ADDENDUM NUMBER ONE 10/26/2018

PROJECT: TOWN OF POMARIA RECERATION RENOVATIONS – 3606.1704
138 FOLK ST.
POMARIA, SC 29126

FROM: Johnson, Laschober & Associates, P.C.
1296 Broad Street
Augusta, GA 30903
(706) 724-5756

SCALE AS NOTED
DRAWING NO. A-701
REV. 1

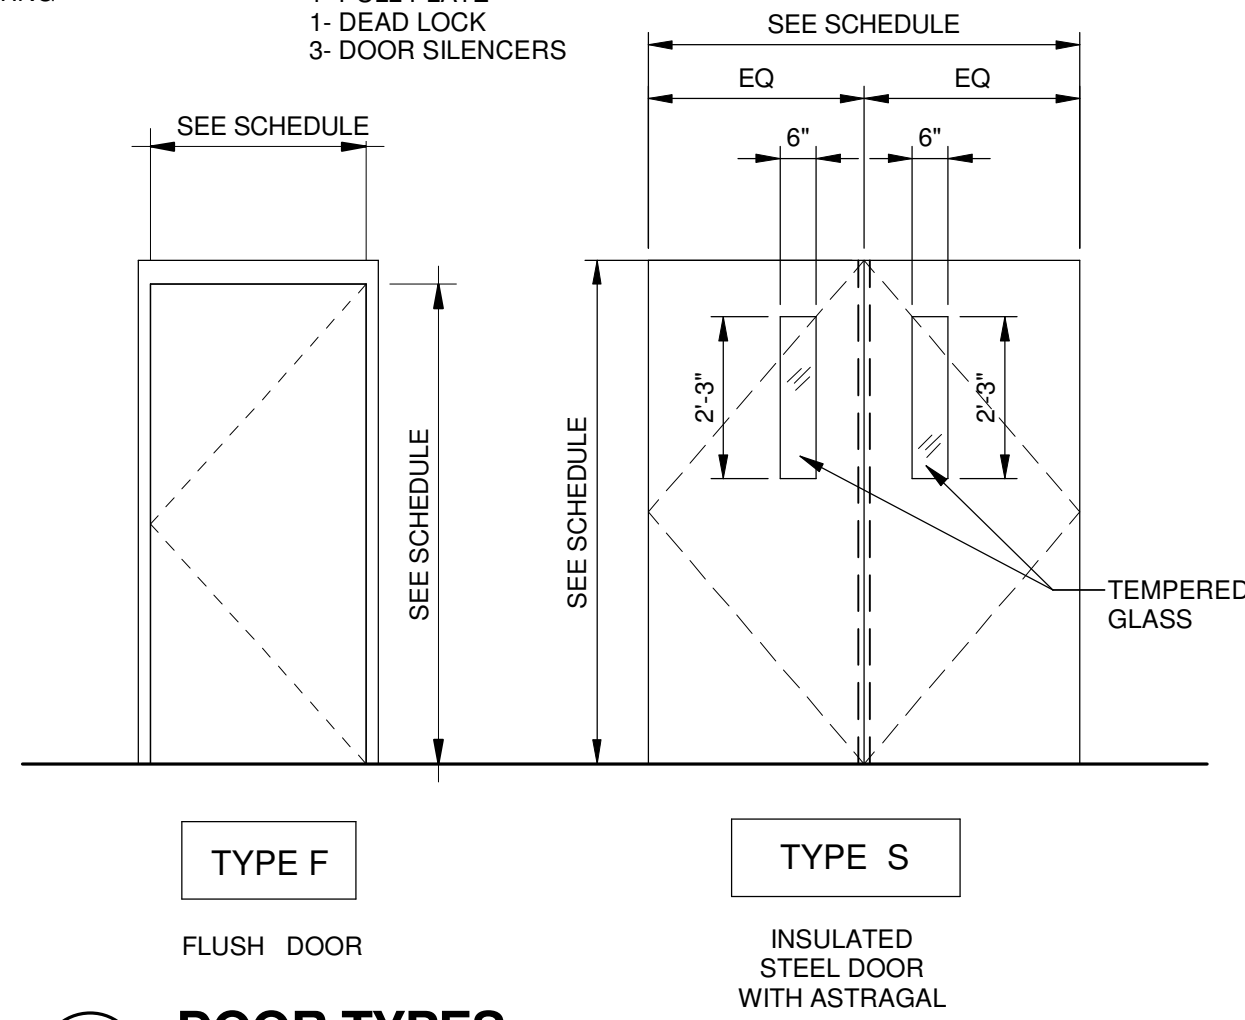
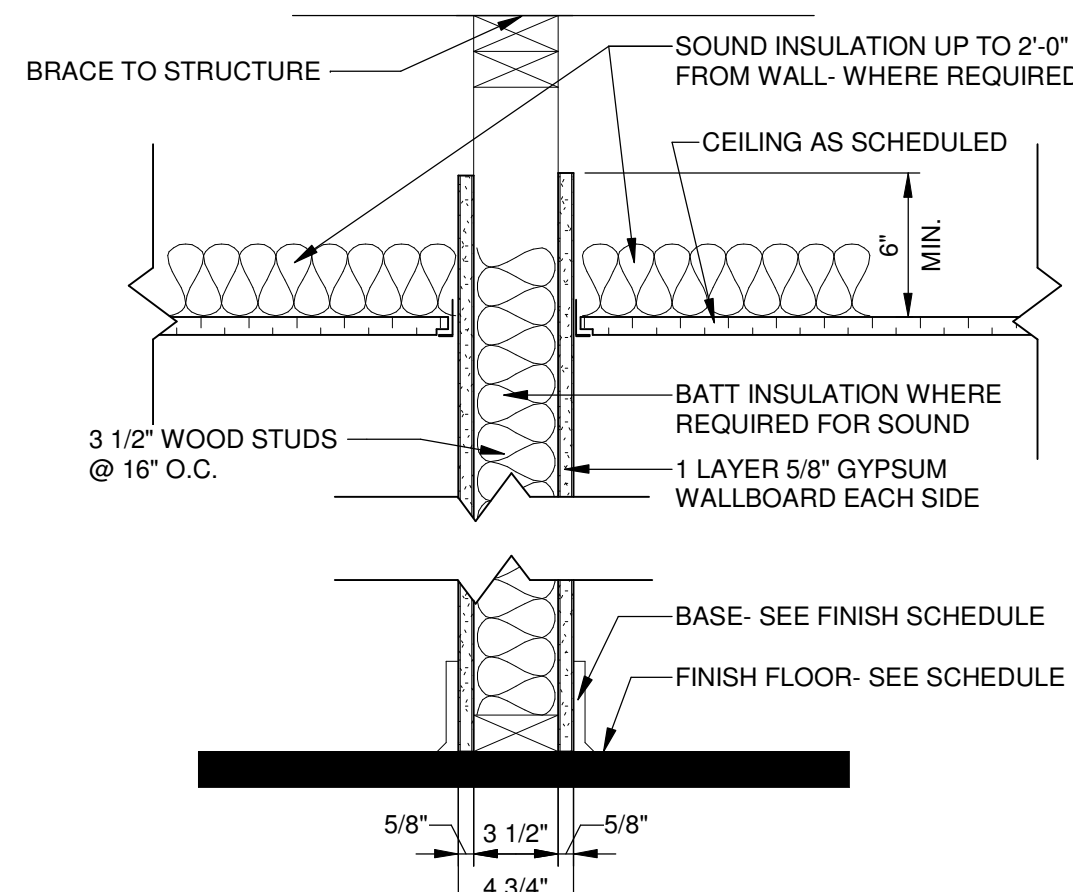
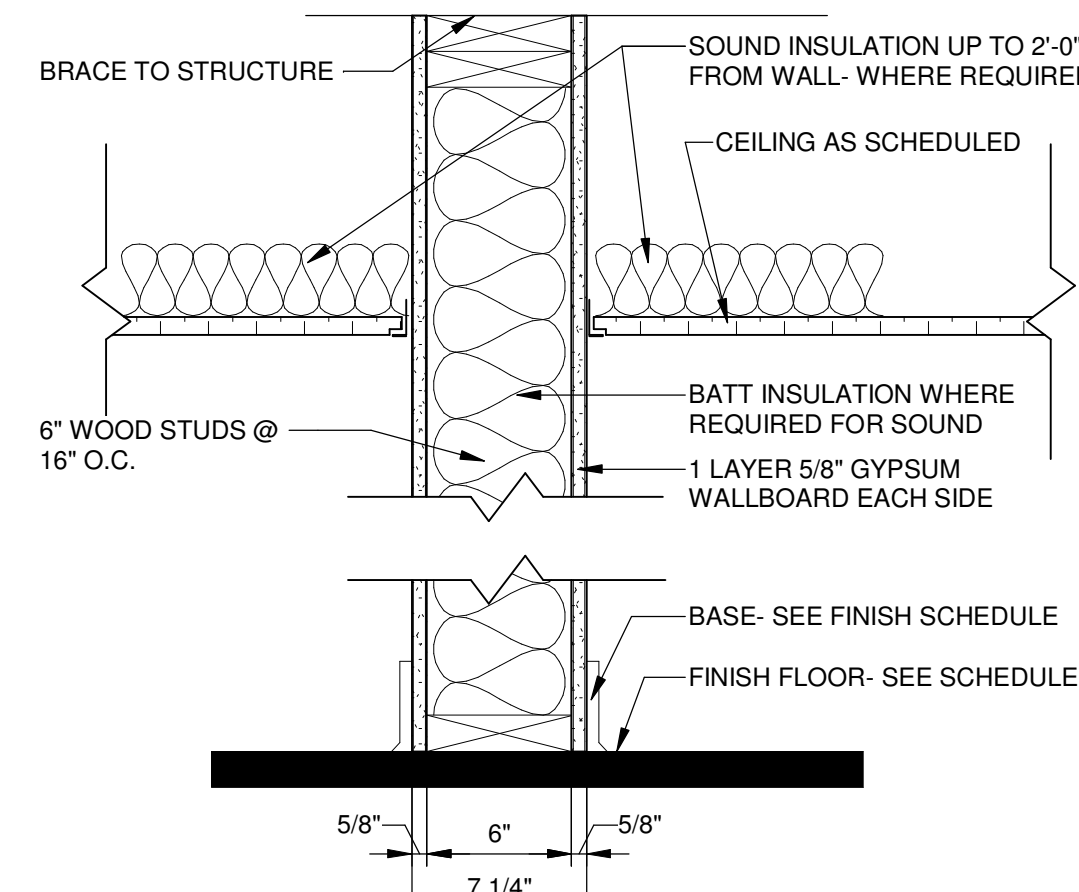
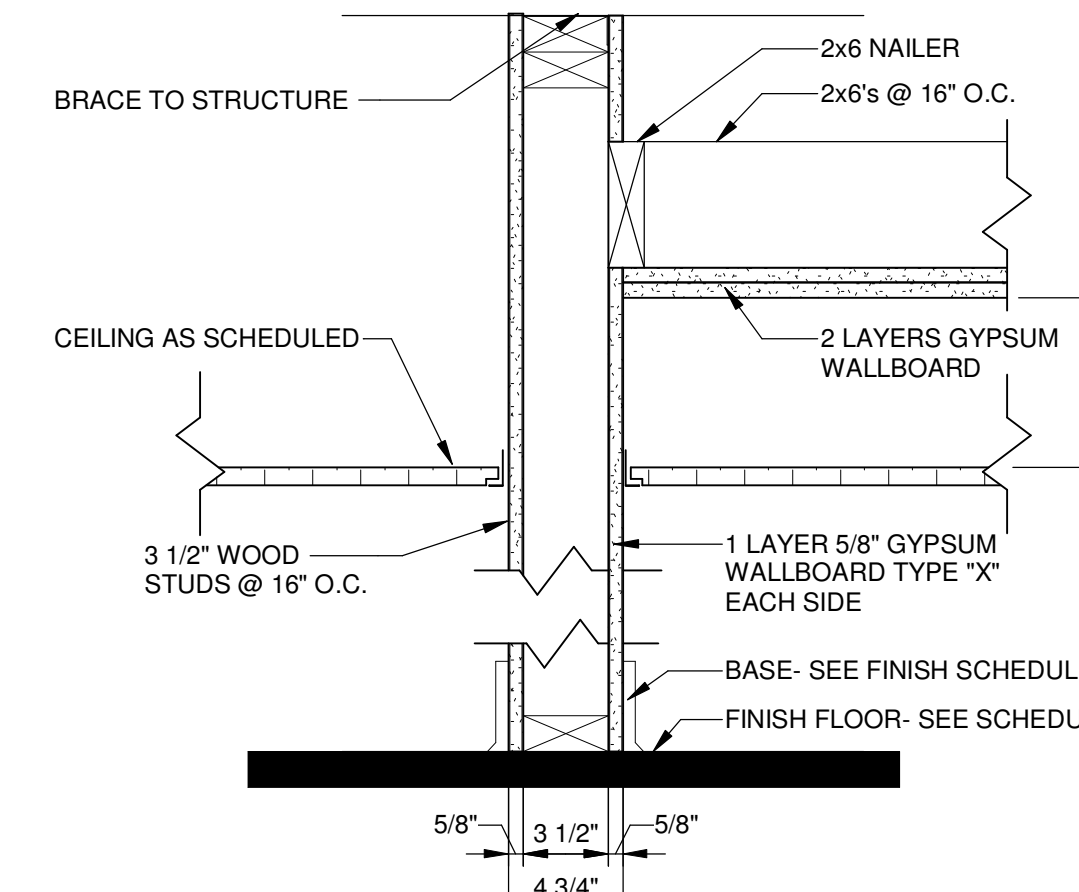
5. All work on the project shall be completed in five months (153 calendar days). See Specification 011600, "Bidders Schedule" for details.
6. The **Door Hardware Schedule** appears on sheets A-701. Specification 08711, "Door Hardware" has been updated to reflect this.

9. The **Door Schedule** has been updated to reflect doors shown on the proposed plan. See drawings A-100 and A-701 for changes.
10. Timeframe for **Standing Seam Metal** substitutions to be submitted has been updated to **5 days before** the bid date. Specification 074113, "Standing Seam Roof Panel" has been updated to reflect this.

SCALE: 1/8" = 1'-0"
 DRAWING NO. **E-201** REV. **1**

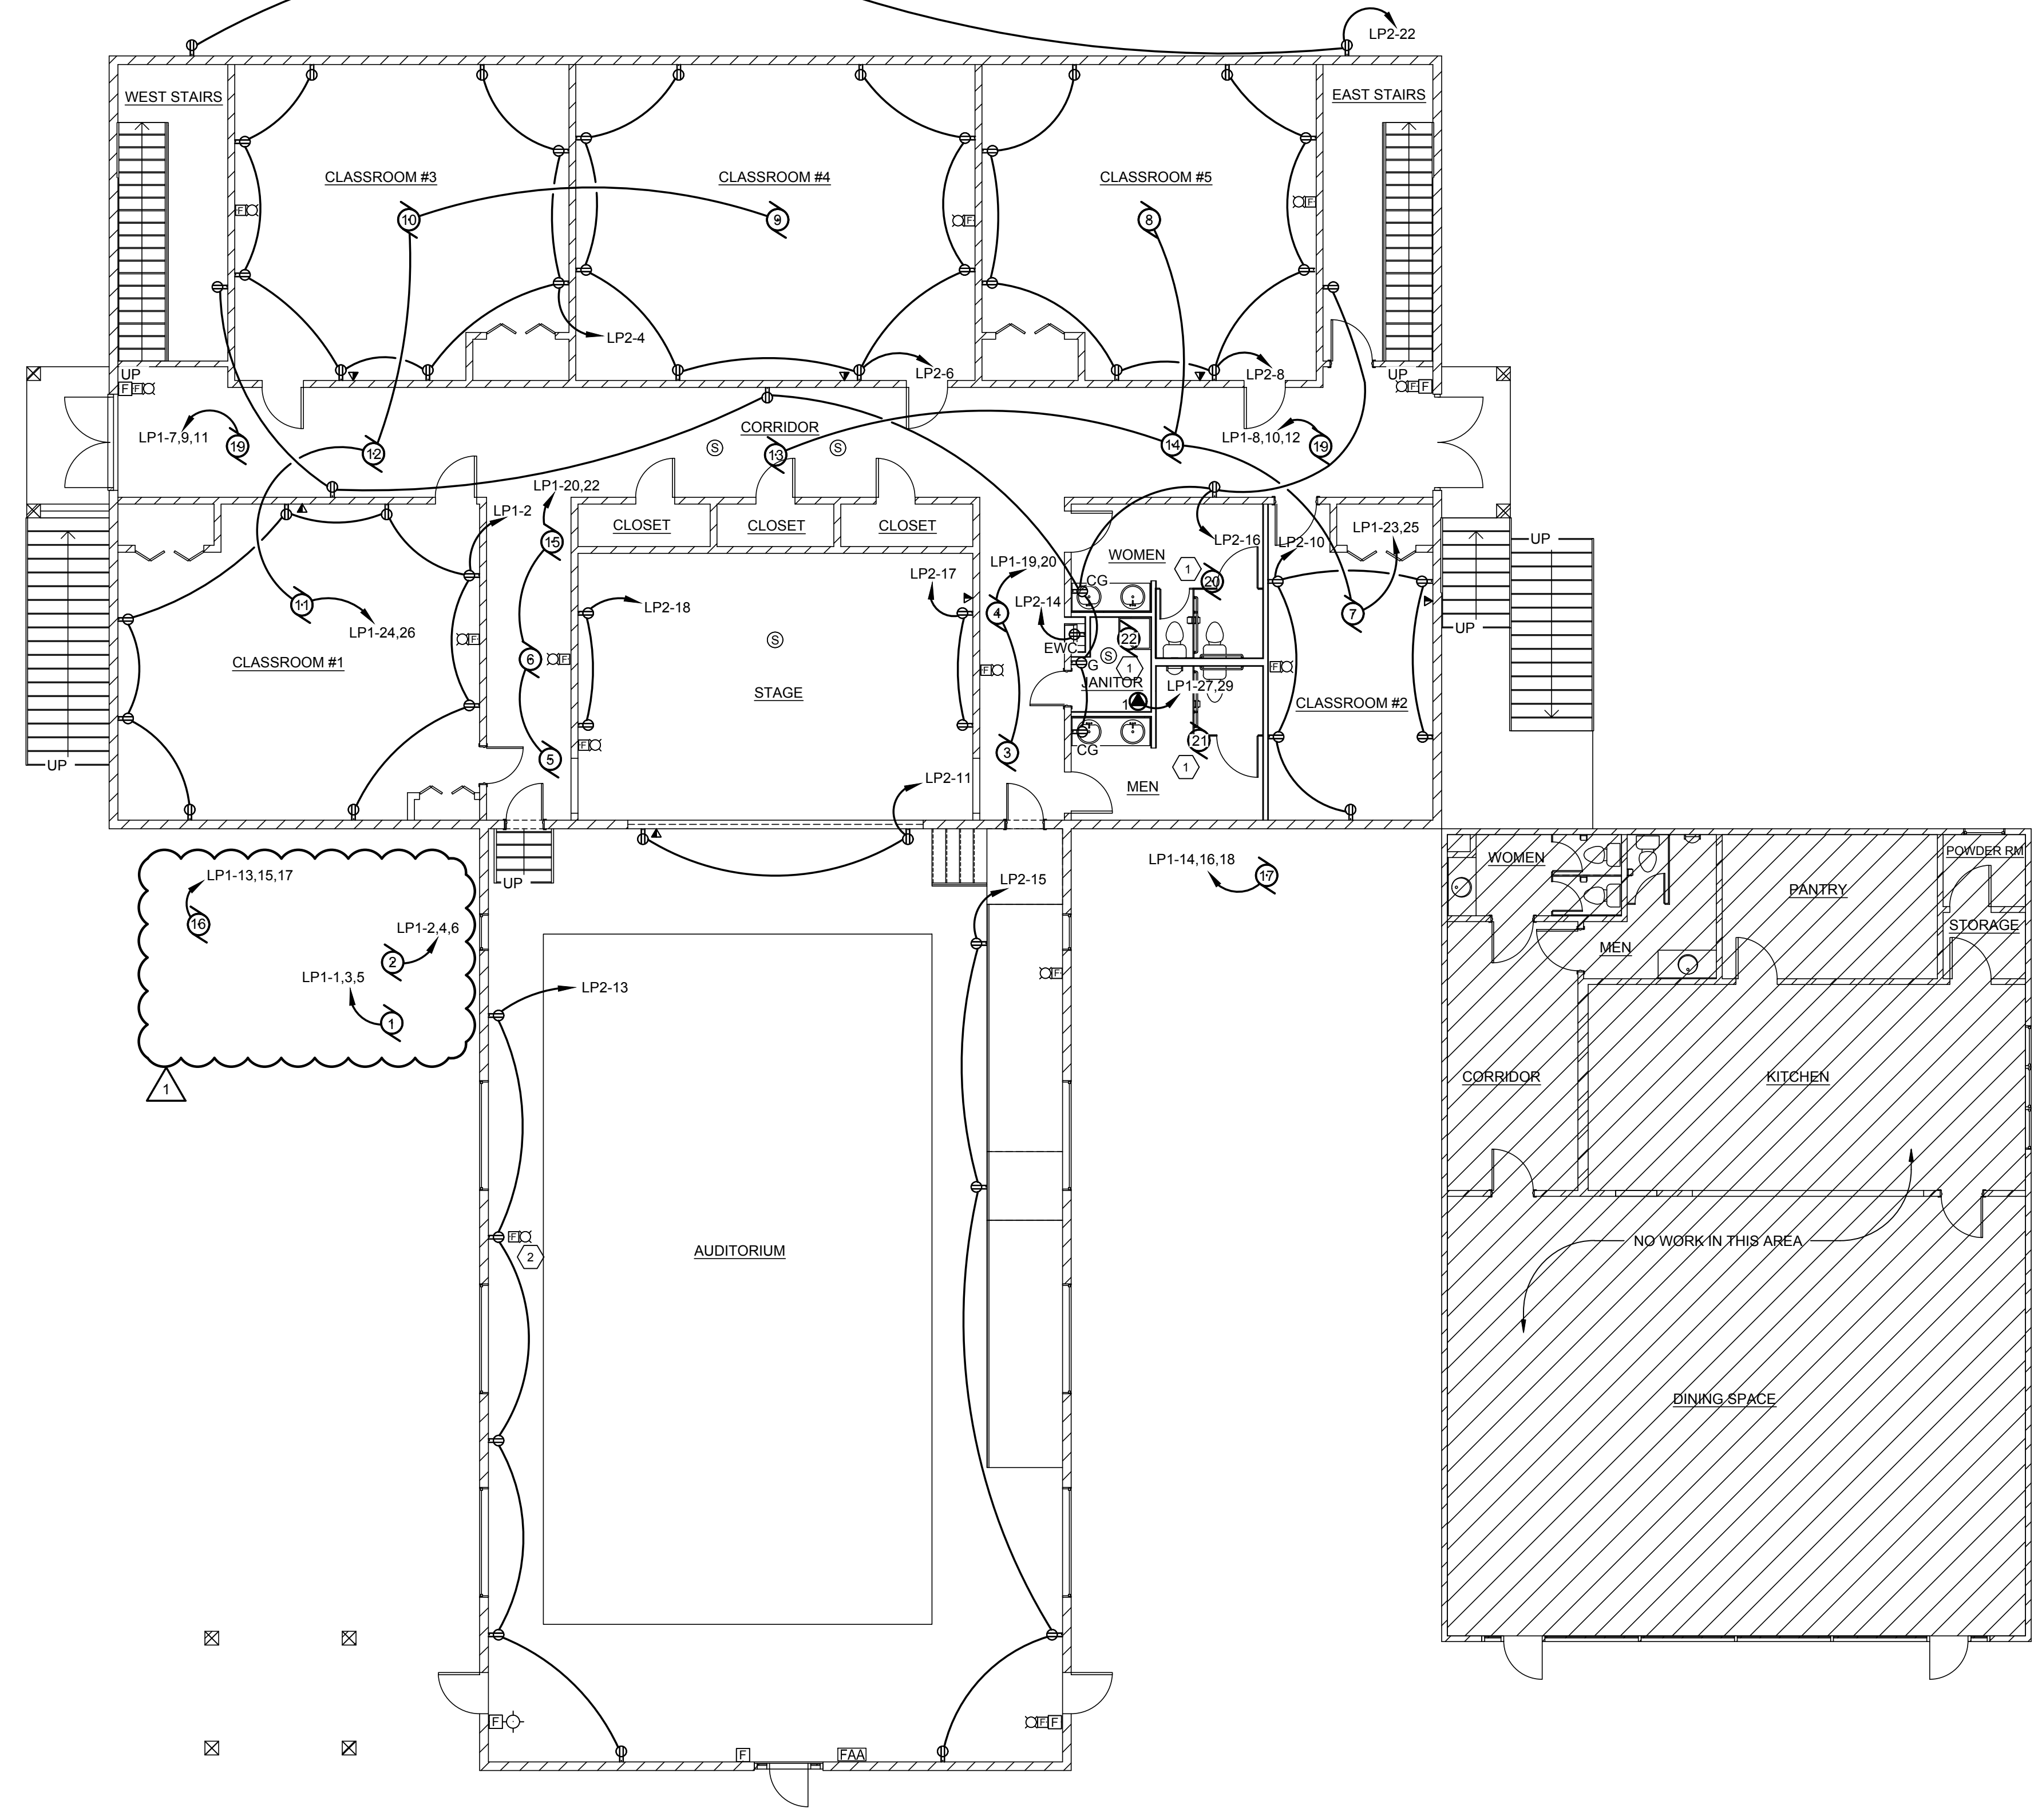
11. Work Restrictions (011000-1.8) have been updated and modified. See Specification 011000, "Summary" for all changes.
12. Placement of OCU-1 and OHP-1 will be in the grass area outside of the existing concrete flume. See M-101 & E-201 for details.

DELETE ALL ELECTRICAL ASSOCIATED WITH VRF SYSTEM IN ITS ENTIRETY, INCLUDING BREAKERS, DISCONNECTS, WIRING AND CONDUIT.

DELETE ALL ELECTRICAL ASSOCIATED WITH DOAS SYSTEM IN ITS ENTIRETY, INCLUDING BREAKERS, DISCONNECTS, WIRING AND CONDUIT.

PROVIDE AND INSTALL ELECTRICAL COMPONENTS FOR NINE (9) EXTERIOR, WALL-MOUNT, SELF-CONTAINED HEAT PUMPS AND ONE (1) SPLIT SYSTEM HEAT PUMP, AS FOLLOWS:
